Technical Service Bulletin

MODEL(S) AFFECTED: **Tennant T3 Scrubber Dryer** (Models manufactured before mid November, 2005.)

SUBJECT: Recovery tank drain hose damage.

BEFORE

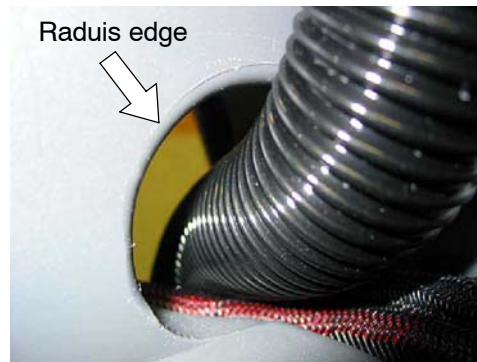
PURPOSE: To prevent drain hose damage, the removal of rotomold material is required as described below.

If you have experienced drain hose damage, perform the following procedure:

Using a round file or dremel, carefully add a 1/4" radius to the upper edge of the passage as shown below. This will allow the drain hose to slide freely through the passage when the recovery tank is lifted up and down.
